## CITY OF PANAMA CITY BEACH

### ADDENDUM NO. 4

### PCB23-35 ITB Conservation Park Classroom

PANAMA CITY BEACH  
**CONSERVATION PARK CLASSROOM**  
100 CONSERVATION DR.  
PANAMA CITY BEACH, FL.

DATE: NOV. 20, 2009  
 SHEET: C403

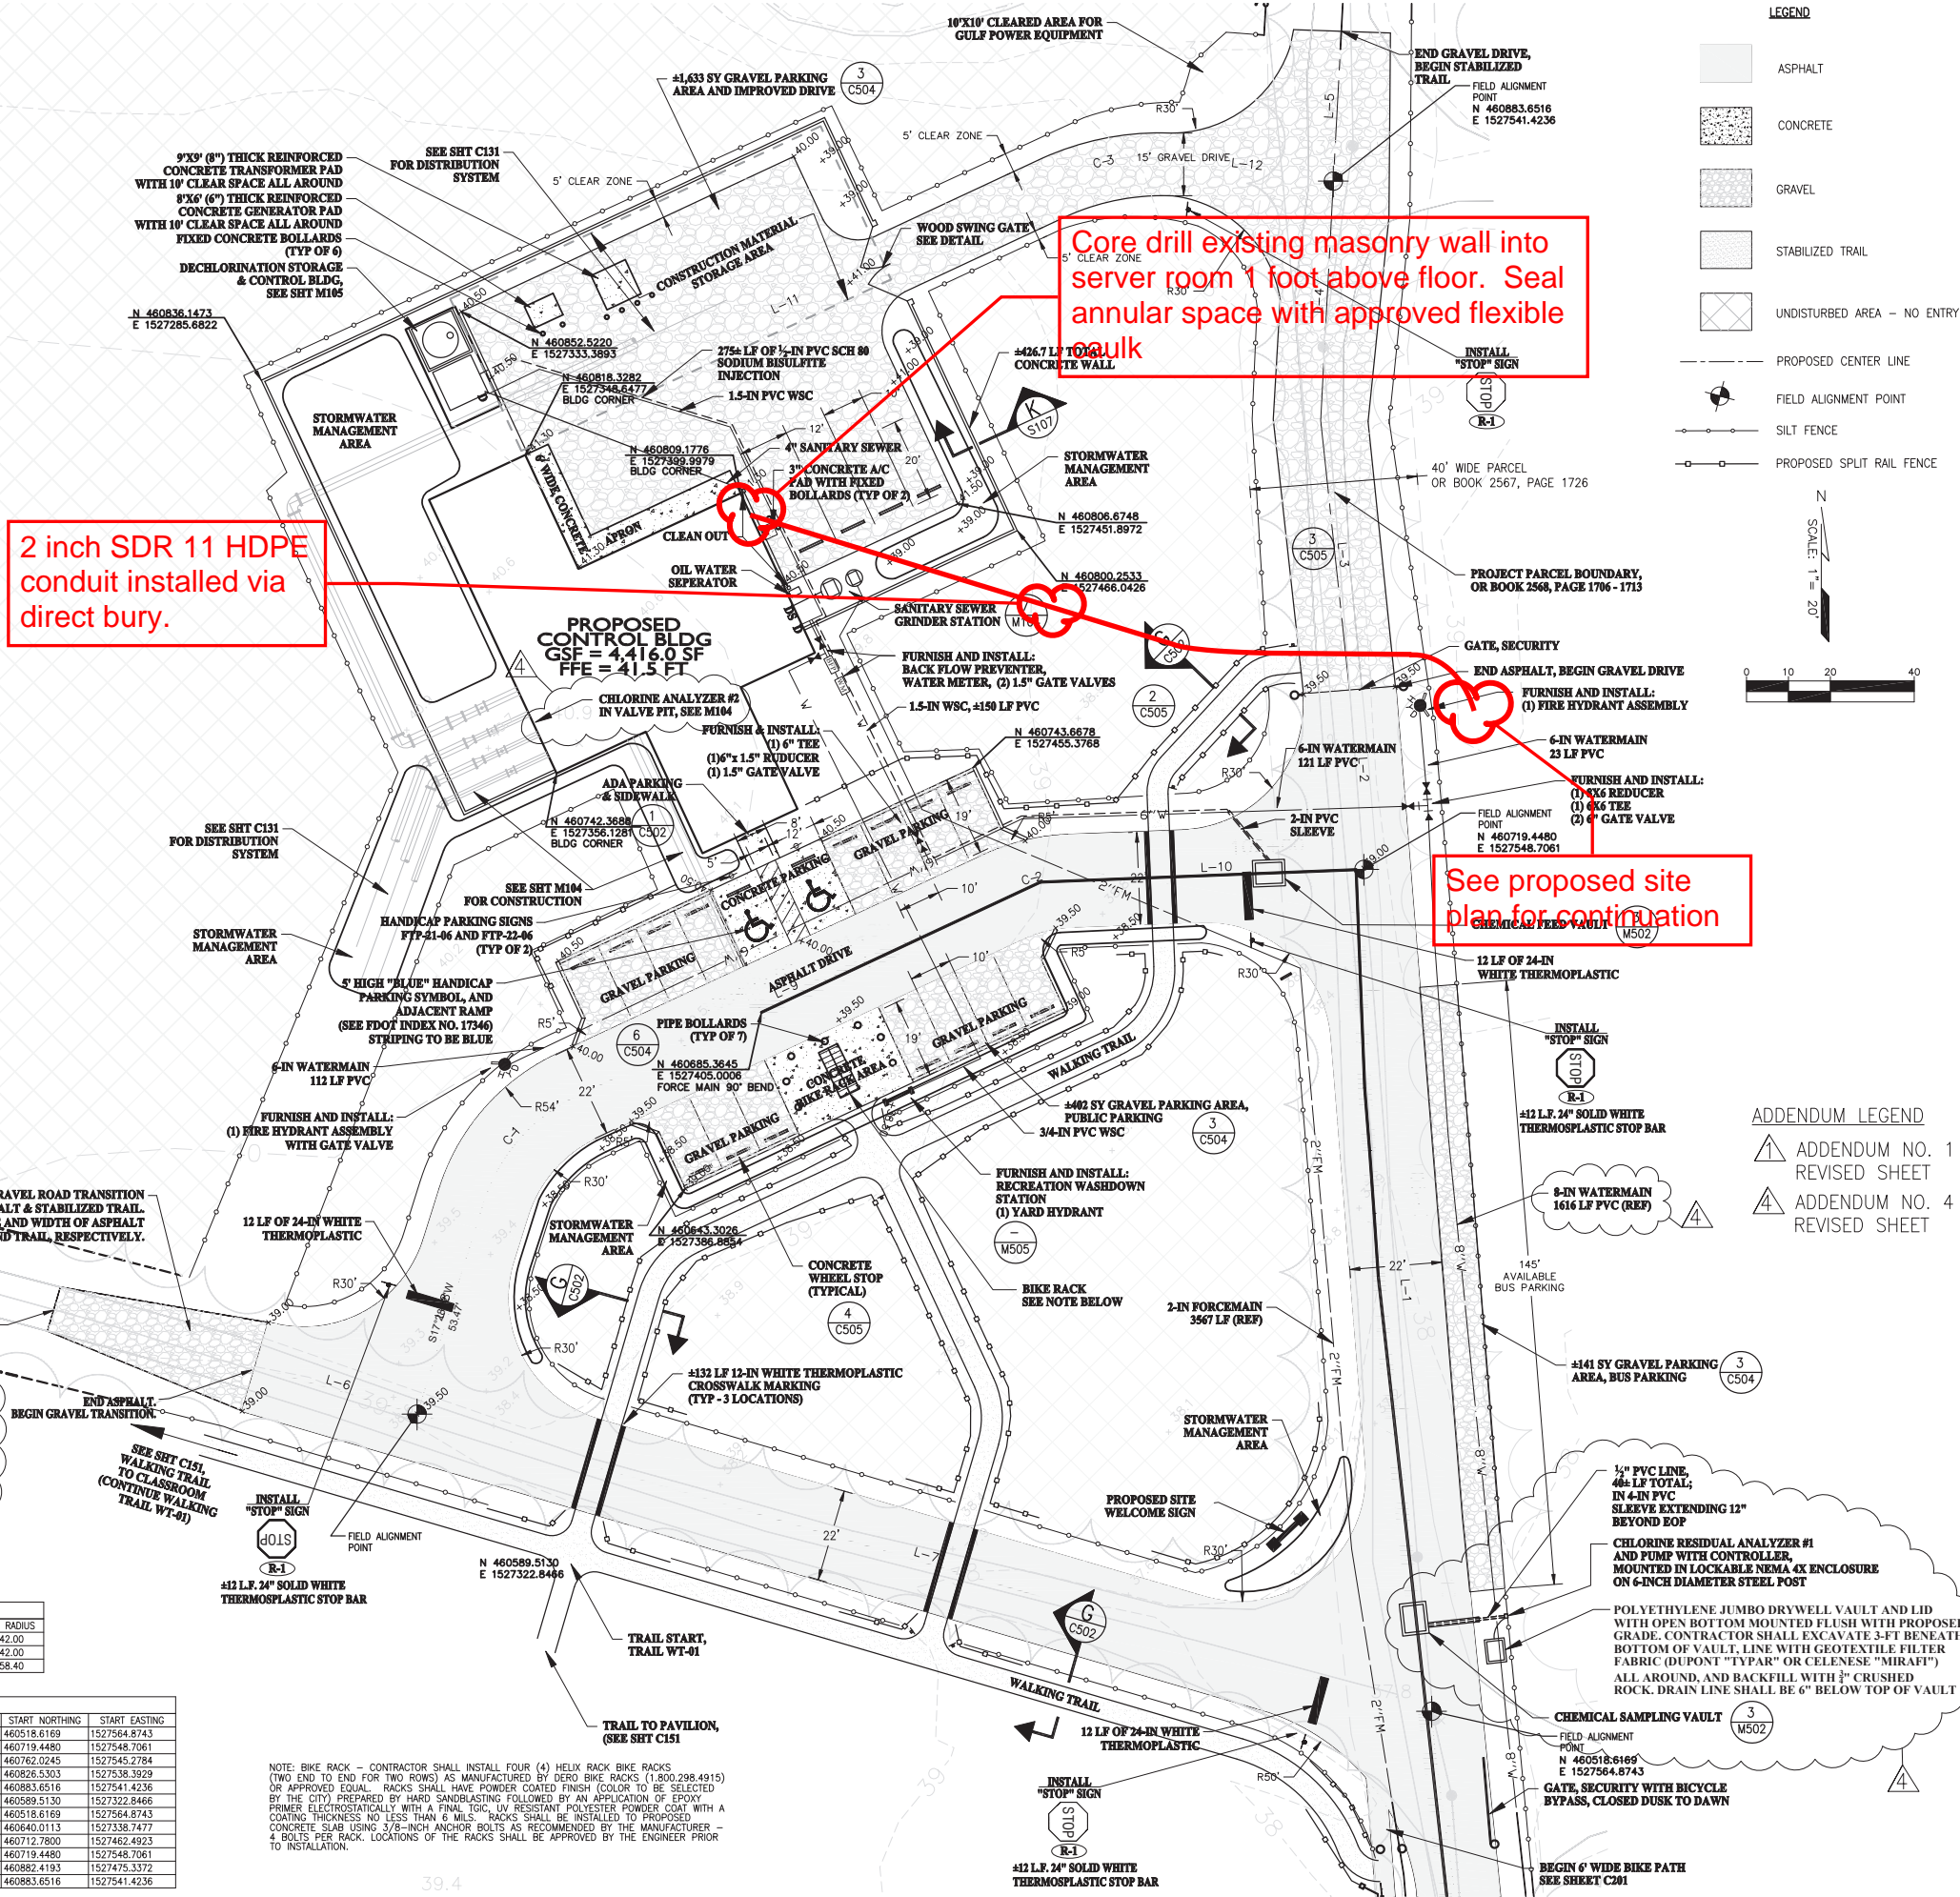
1. Please provide additional information regarding the fiber optic interconnection between the existing and proposed buildings.

**R1.** See attached drawings (U1 – Utility Plan rev. 1 and Existing Site and C-403 Utilities Plans) showing the routing of the interconnection. All conduit is to be ASTM F2160 SDR 11 and installed via direct bury except the section beneath the paved parking lot access road which shall be installed via directional drill per City standard details provided for sewer forcemain crossing. Portions of conduit for building wall and floor penetrations shall be as specified for electrical systems. Pull boxes shall be Quazite Model PG2424BA24 (24 in x 24 in x 36 in deep) or approved equal. Fiber shall be 12 fiber single mode pre-terminated with 15 feet minimum tail extending from end of conduit inside building. All conduit and fiber to be installed by contractor.
